ACCURING TABORN Building Grant Application Construction, Renovation, or Repair

AUGUSTA COUNTY FIRE TRAINING SIMULATOR EVALUATION 180 TECHNOLOGY DRIVE - AUGUSTA COUNTY, VA

AUGUSTA COUNTY FIRE TRAINING TOWER

STRUCTURAL EVALUATION

Figure 1: Concrete Curb at Building Perimeter Base.

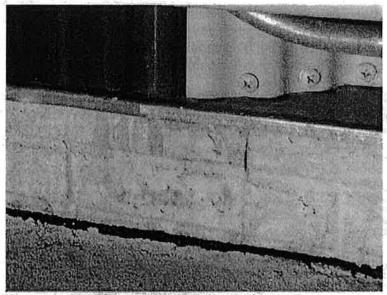
- a. Concrete Curb: Spalling, cracking, deterioration, settlement, or damage of any type was not visibly evident at any location along the perimeter "concrete curb" of the subject structure during the time of the site visit (See Figure 1). Furthermore, based upon our review of the structural document Sheet SO, "General Notes and Details" by Behlen Industries, LP, dated Nov 30, 2006, concrete exposed to exterior elements shall be air entrained. Therefore, it is our opinion that the in-place concrete is properly specified to resist freeze thaw damage. Additionally, per Sheet SO "General Notes and Details", the concrete cover requirements per 4G appear to adequately protect the reinforcing steel within the wall. Based upon our review of the above listed documents, it is the opinion of Schnitzhofer & Associates, LLC that the in place perimeter "concrete curb" is not experiencing visible damage, is properly specified within the signed and sealed "General Notes" for this project, and shall not be in need of structural repair and/or reinforcement at this time.
